TECHNICAL SERVICES BULLETIN

Document ID: 8-23-GL-00-005

Bulletin Title: VF8 & VF9_AGS Pigtail Wiring Harness rework instructions

Date of issue: EN Version 1.0 / 22 May 2023

4.0) Solution Summary

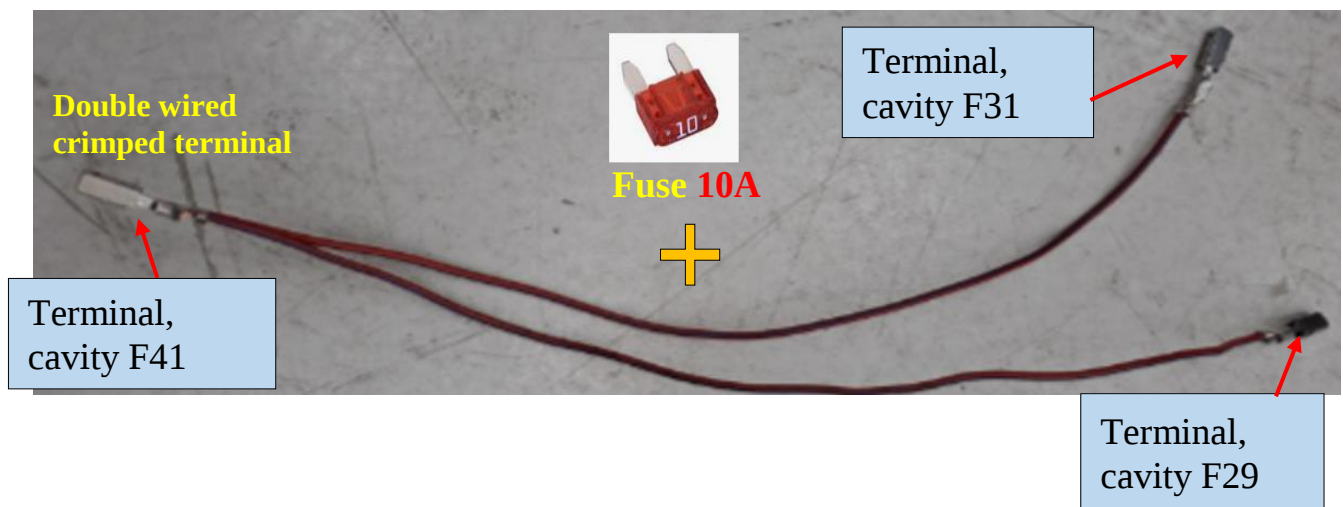
Vehicle do not go to sleep which drains the 12V battery current due to Active Grille Shutter [AGS] sleep current is above specification.

Apply new AGS pigtail harness part on engine fuse box of the vehicle.

Step 2: Overview of Terminals interchange

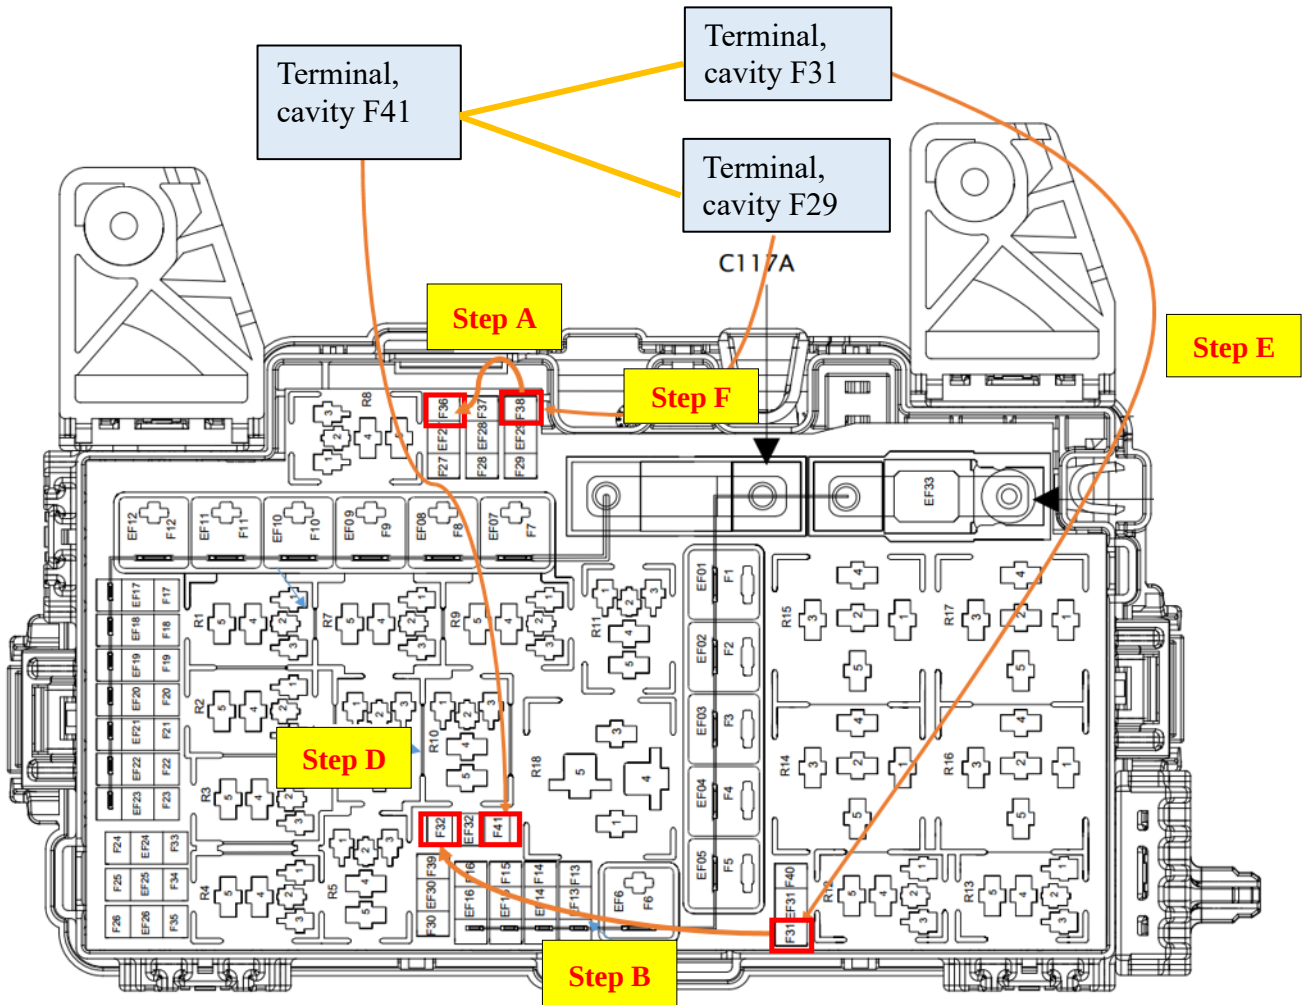
- A. Remove F38 and connect in F36
- B. Remove F31 and connect in F32
- C. Take AGS pigtail wire from kit
- D. Insert double wire crimped terminal in F41
- E. Insert another end of 1 wire to F31
- F. Insert another end of 1 wire to F38

Step A: Remove F38 and connect in F36

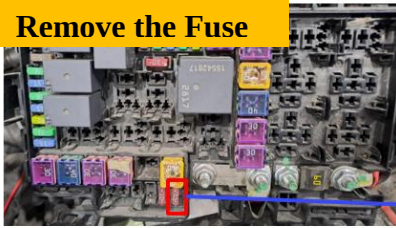
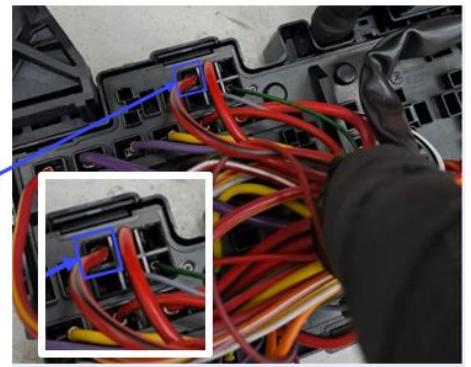
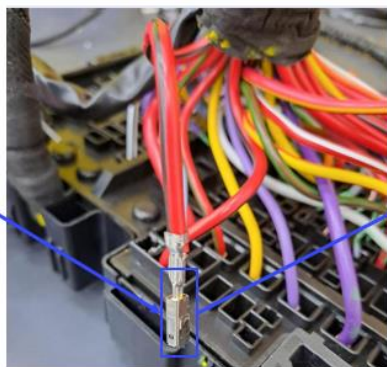
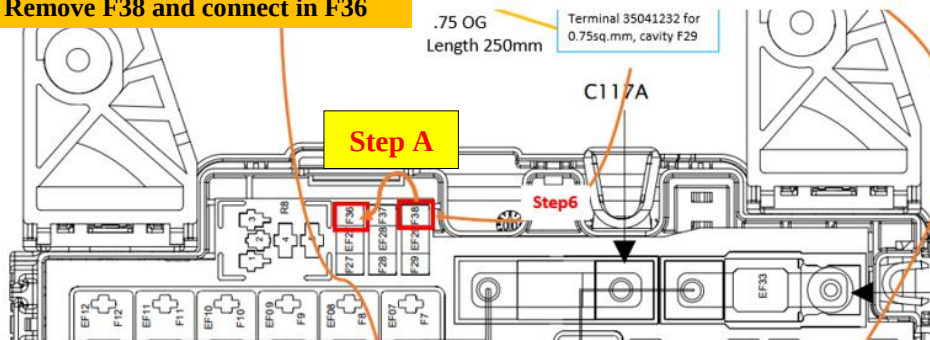
Note: Remove the E-valve & AGS Fuse 7.5A as shown in below figure before removing the terminal

Remove F38 and connect in F36

Step B: Remove F31 and connect in F32

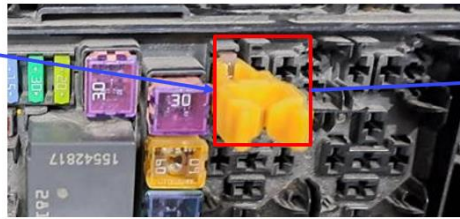
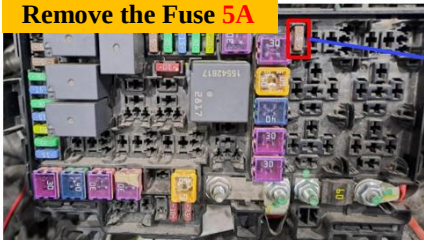
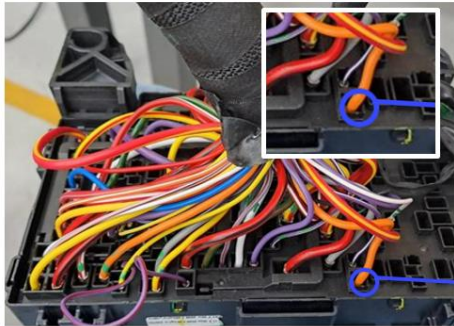
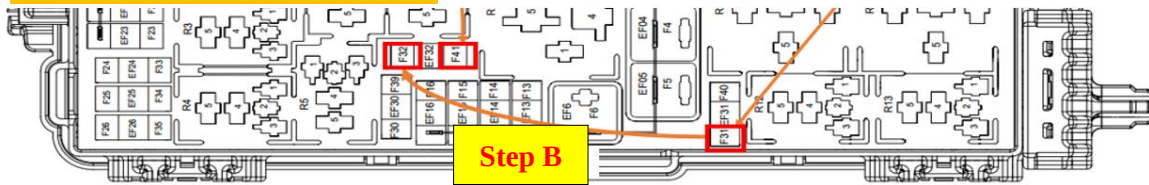
Note: Remove the Compressor Heater Fuse 5A as shown in below figure before removing the terminal

Remove F31 and connect in F32

Step E: Insert another end of 1 wire to F31

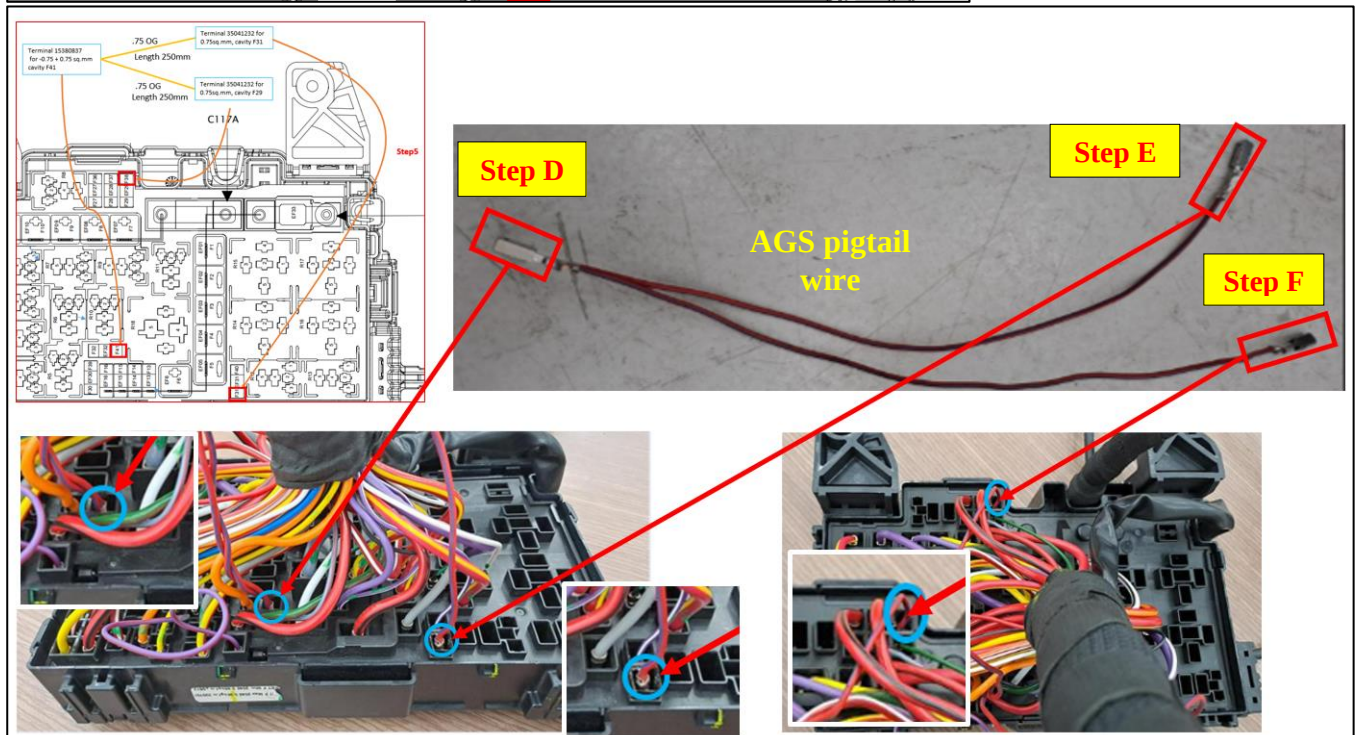
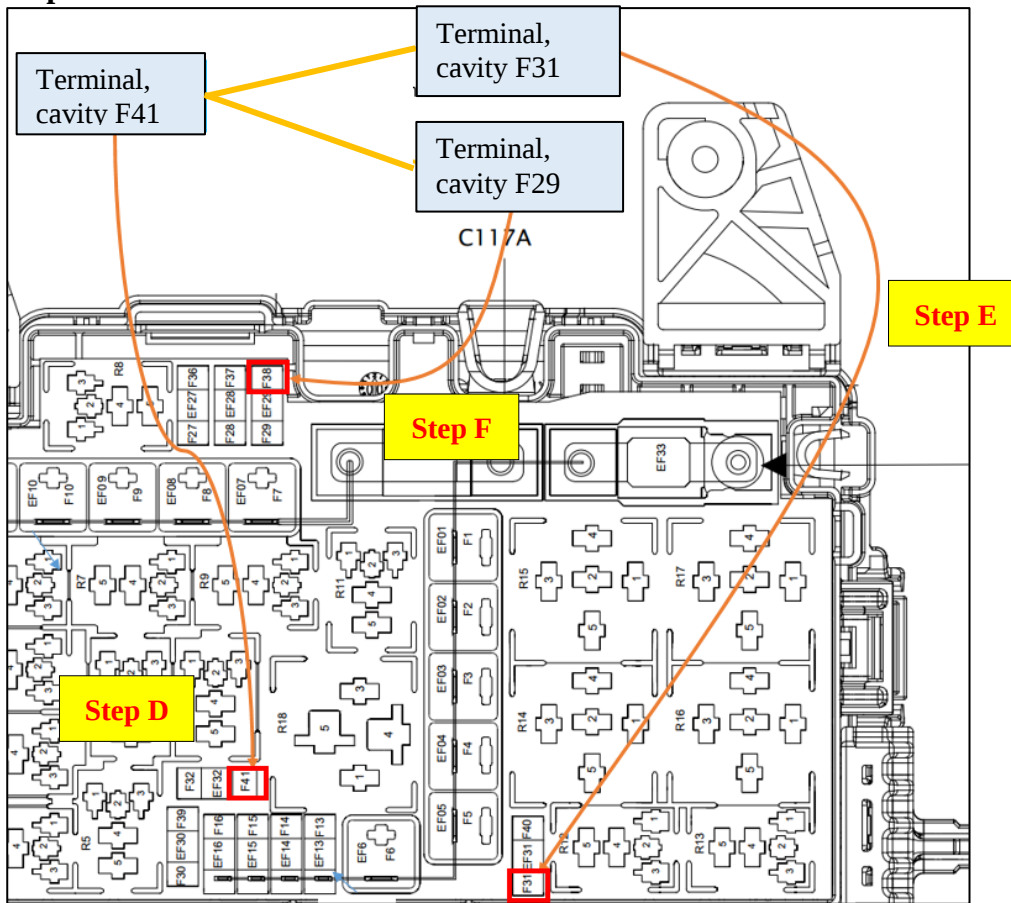
Step D: Insert double wire crimped terminal in F41

Step F: Insert another end of 1 wire to F38

Installation Note: Ensure the modified wires are connected properly in terminals by pulling it with small hand force.

Step 3: Visual Inspection Check

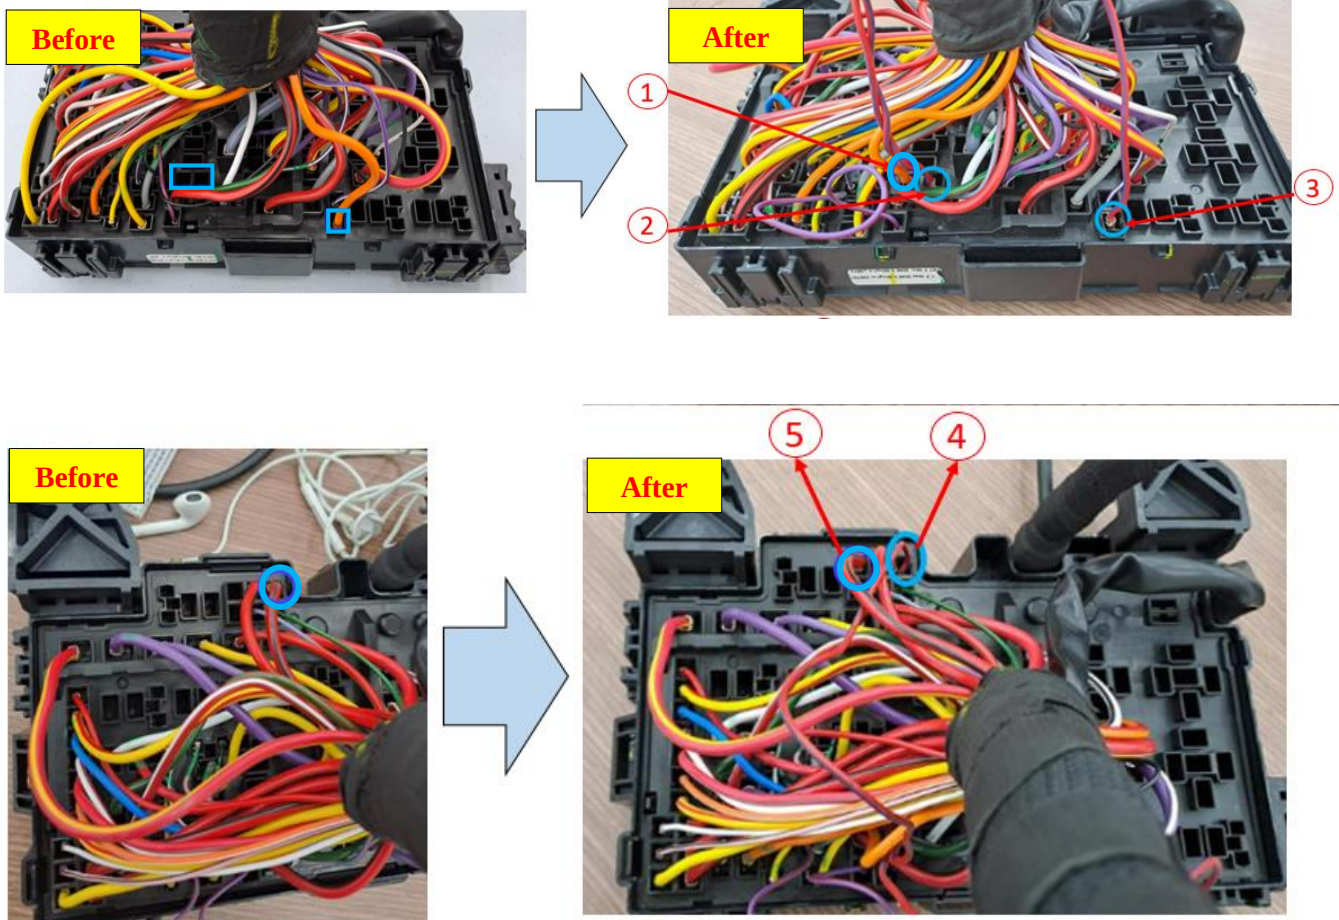
- i. **Check Point:** Ensure the modified wiring harness terminal installed position is consistent with the below shown figure

Step 4: Inspection check with Multi Meter

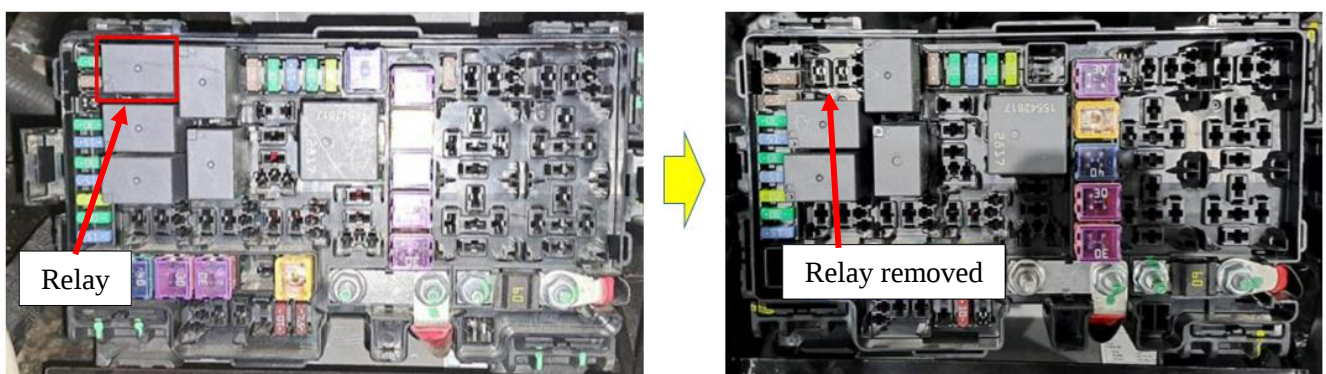
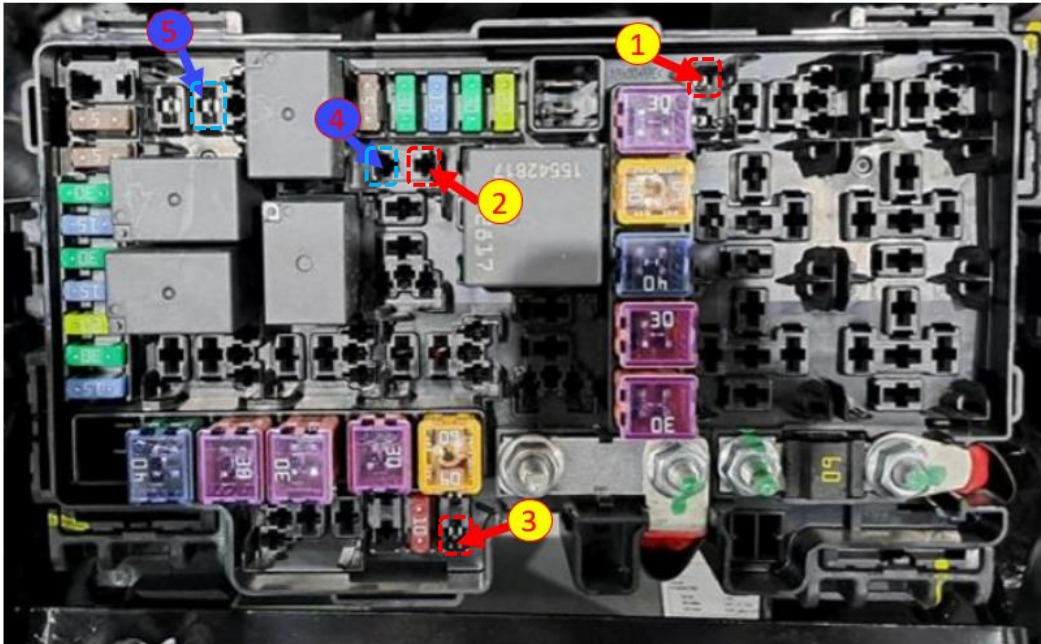
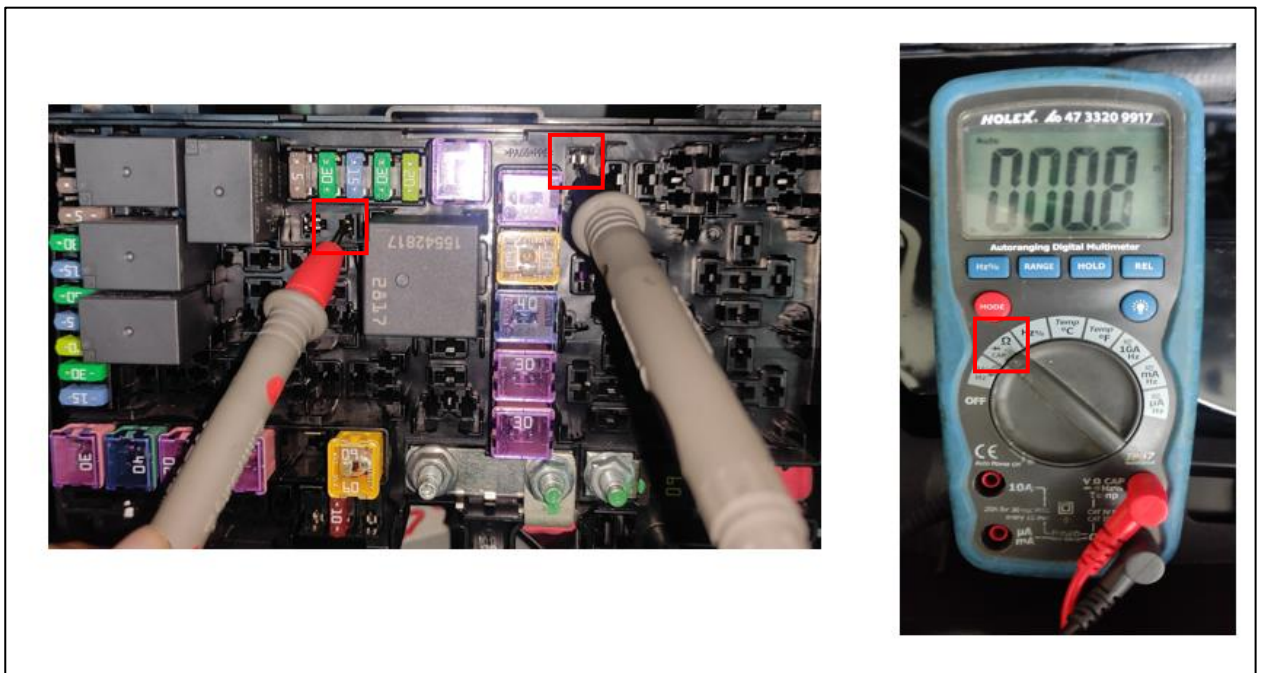
- i. Remove VCU Main Relay 35A from Fuse box (as shown below) to measure the conductive between the terminals for ensuring proper rework completion

- ii. **Check Point:** Use Multi-meter to measure the terminals (0.2-1.2 Ohm is Preferable)
- ❖ Three Terminals (1, 2 & 3) are conductive to each other.
 - ❖ Two Terminals (4 & 5) are conductive to each other.
- Note:** Insert Relay 35A, which removed at Step 4.

Step 5: Insert Fuses in Engine Fuse box

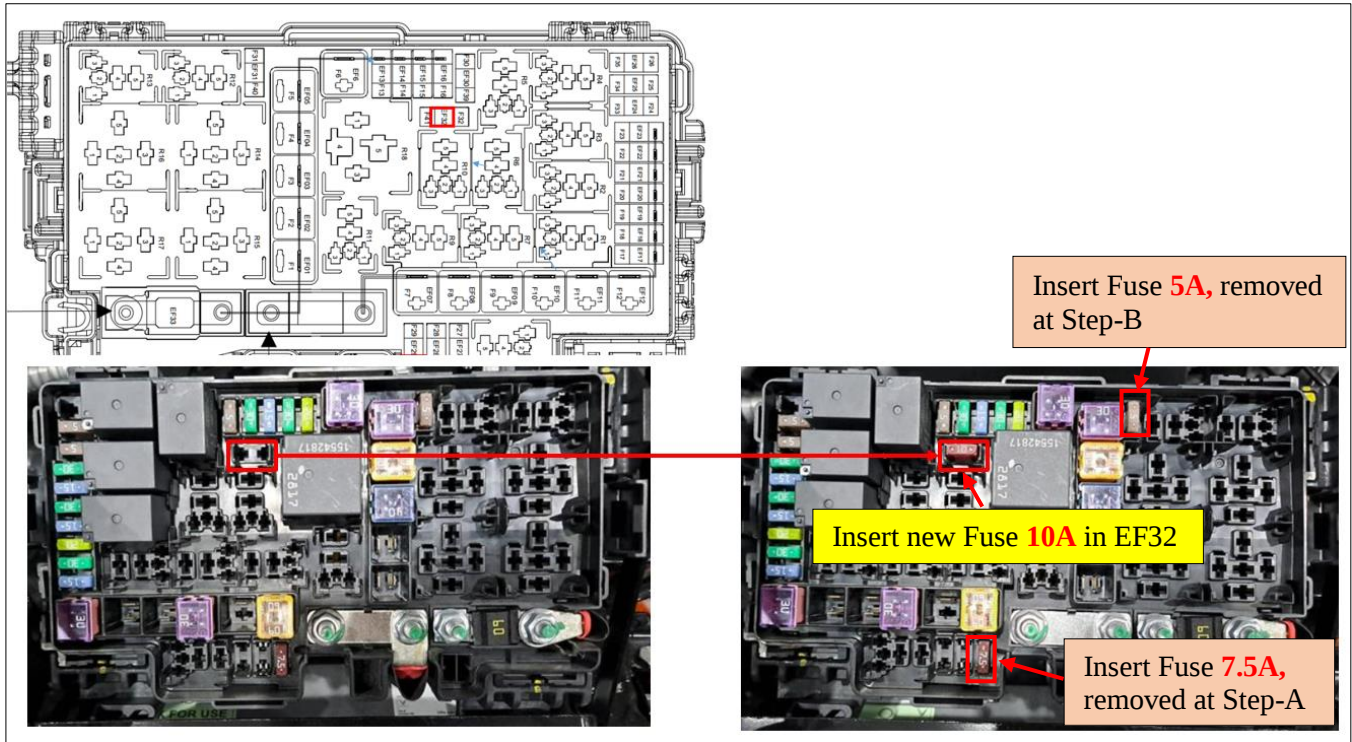
- i. Insert new Fuse 10A in EF32 as shown in below figure
- ii. Insert Fuse 5A, which is removed at Step-B
- iii. Insert Fuse 7.5A, which is removed at Step-A
